Urgent Field Safety Notice

CHC16-09.A.OUS

ADVIA® Chemistry Systems

Chemistry Calibrator Reassignment for the ADVIA® Chemistry Direct Bilirubin Assay (DBIL_2)

Figure 1. Patient sample correlation of the Direct Bilirubin Assay (DBIL_2) and bias plot before and after calibrator value reassignment in mg/dL

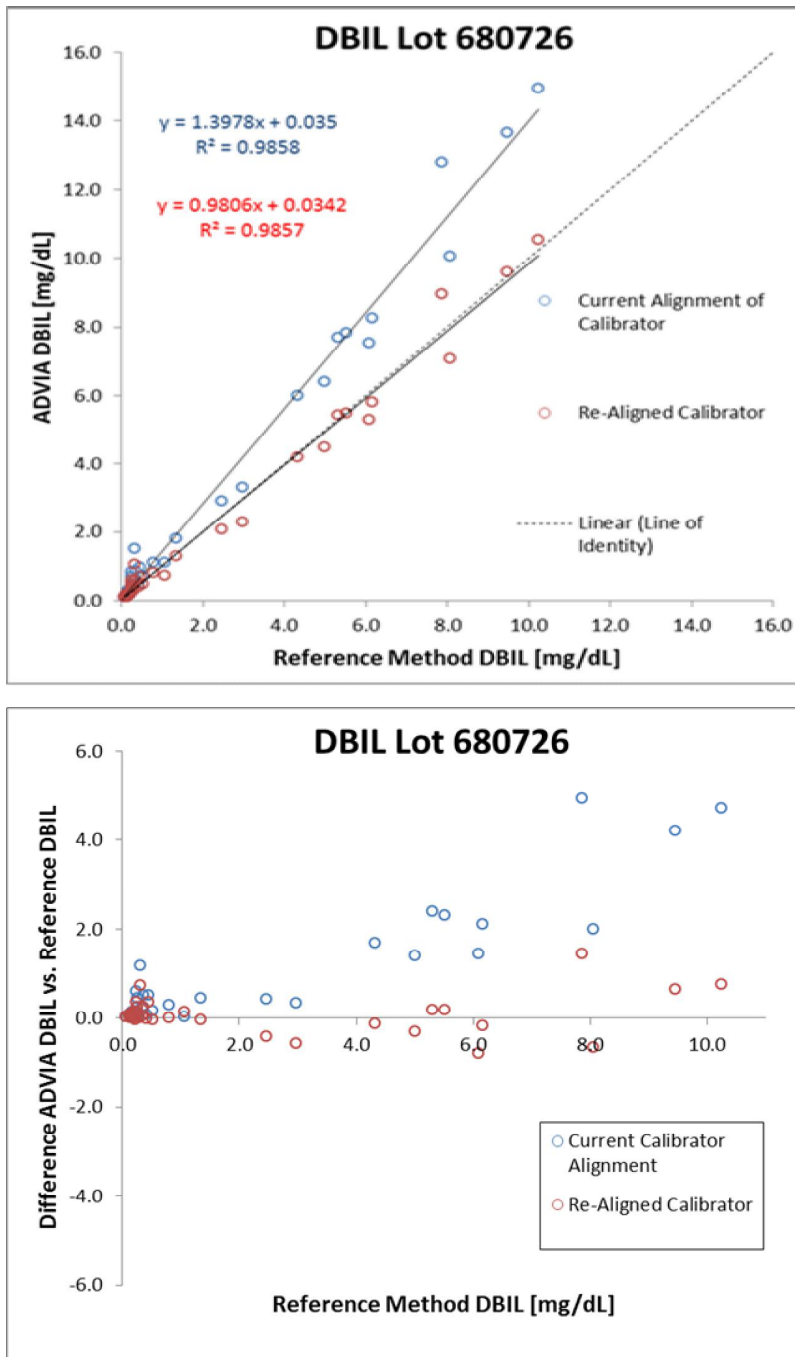
A representative correlation of DBIL_2 before and after calibrator value reassignment using patient samples can be seen in Figures 1 and 2 below. Figures 1 and 2 demonstrate that after reassignment of the DBIL_2 calibrator value for Chemistry Calibrator Lots 680726 and 680726 A through D, the bias is corrected and DBIL_2 recovery is aligned to the reference method.

To correct the positive bias, the ACV for DBIL_2 has been reassigned for the lots in Table 1. Refer to Table 2 for the reassigned values.
